DRAWING AMENDMENTS

Please amend FIG. 23 as highlighted in red on the Annotated Marked-up Drawings Sheet attached hereto and reflected in the Replacement Sheet also attached hereto. An explanation of these amendments along with support in the specification for these amendments is provided below.

FIG. 23

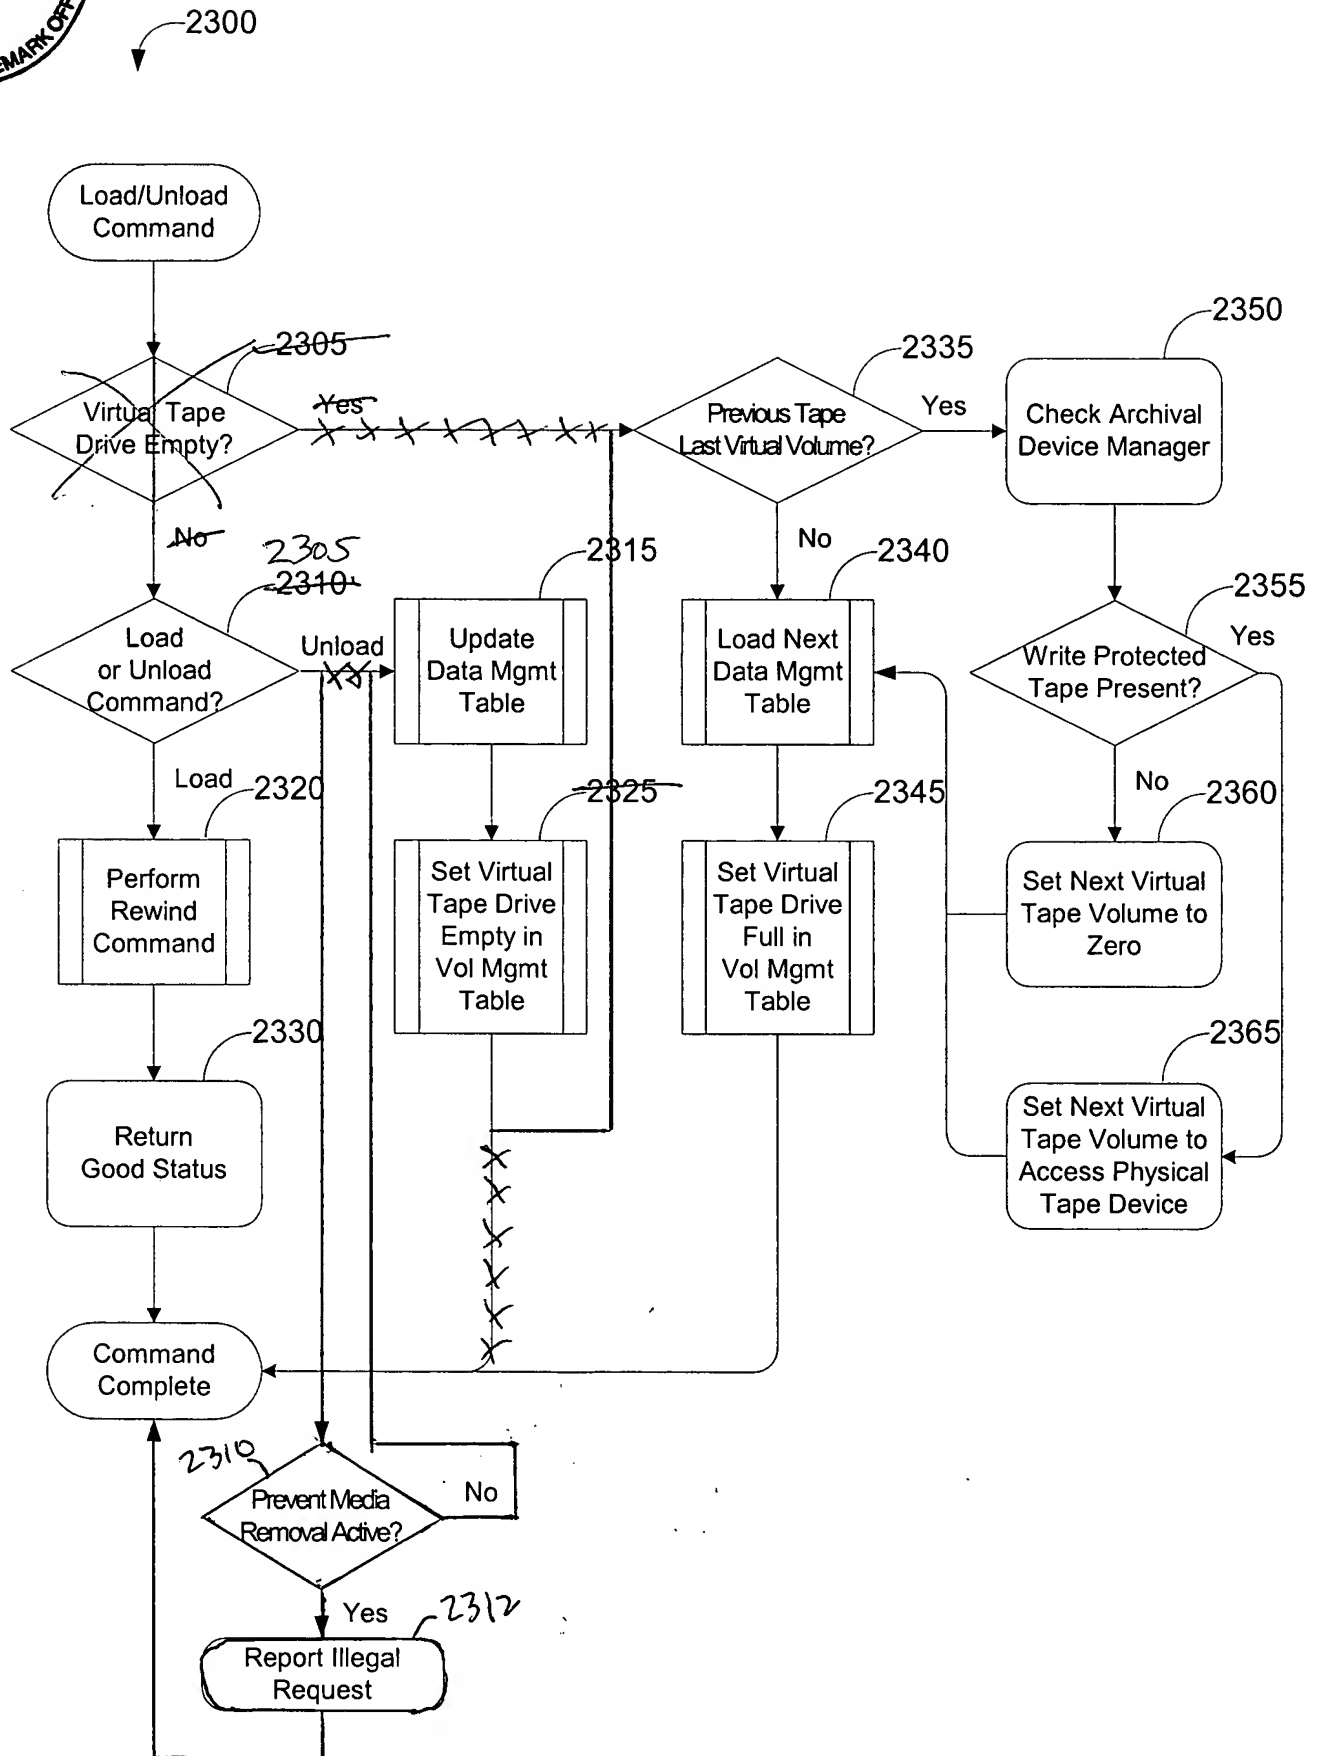
Pease delete block "Virtual Tape Drive Empty?" and associated connecting lines, labels and reference numeral 2305. This block is not referenced in Spec. ¶[0070].

Please add block "Prevent Media Removal Active?" and block "Report Illegal Request" and associated connecting lines, labels and reference numerals 2310, 2312. *See* Spec. ¶[0070], as amended:

Further, please combine block 2315 and block 2325 as a single block 2315, deleting reference numeral 2325 not referenced in the specification. Add a connecting line to block 2335. *See* Spec. ¶[0070], as amended:

Finally, for readability, please allow the relocation on the Replacement Sheet of the resulting blocks, connecting lines and reference numerals as compared to the Annotated Marked-up Drawings Sheet.

if the load bit is set to zero, the prevent media removal state of the virtual tape drive is checked to allow the virtual tape drive to be unloaded. If prevent media removal is active **2310**, the unload command is terminated with a check condition status with a request sense data buffer constructed to report an illegal request **2312** error condition; and the request sense data buffer flag is set to a valid state. If prevent media removal is not active, the volume data management table is updated **2315**

If prevent media removal is not active, the volume data management table is updated **2315** to record any pending write operations and the volume management table is updated to indicate the virtual tape drive is empty **2315**. If the previous virtual tape volume was not the last volume **2335** . . .
